CITY OF MOUNTAIN VIEW

ENVIRONMENTAL PLANNING COMMISSION STAFF REPORT FEBRUARY 3, 2021

5.2 Study Session to Discuss Proposed General Plan and Zoning Map Amendments and a Planned Community Permit and Development Review Permit to Allow a 329-Unit Addition to an Existing 402-Unit Residential Development and New 1.34-Acre Public Park, all on 14.5-acre site bounded by West Middlefield Road, Moffett Boulevard, Cypress Point Drive and State Route 85 (referred to as the 555 West Middlefield Road project)

Figure 3: Previous Block B Building Elevation at the Corner of Moffett Boulevard and Cypress Point Drive, Presented at 2017 City Council Study Session

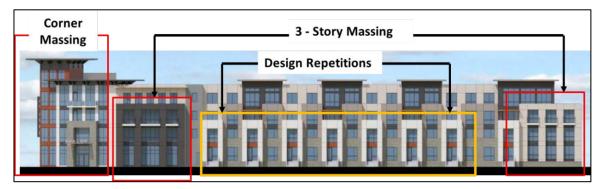
- Reduce the four-story height along Cypress Point Drive and introduce fourthstory step backs;
- Introduce increased building setbacks along Cypress Point Drive;

- Eliminate the fifth-floor tower element at the intersection of Moffett Boulevard and Cypress Point Drive; and
- Increase building separation at pinch points to better coordinate on-site development and comply with the R4 Ordinance.

The project design has evolved significantly from the first submittal. The initial proposal included a fairly contemporary building design with a commercial and office-type appearance. At the April 2017 Council Study Session, Council provided specific direction on design modification as discussed earlier in the report.

Based on design direction received from Council and multiple DRC meetings, the applicant has worked with staff to revise the prosed design to include traditional residential elements in the contemporary residential building design. Importance has been given to better transitions between the proposed buildings, between existing and proposed buildings on-site, and appropriate transition in the neighborhood. Some of the key design changes include:

- Reducing the massing of the tower element at the corner of Cypress Point Drive and Moffett Boulevard from five stories to four stories and further stepping back the fourth story along Cypress Point Drive.
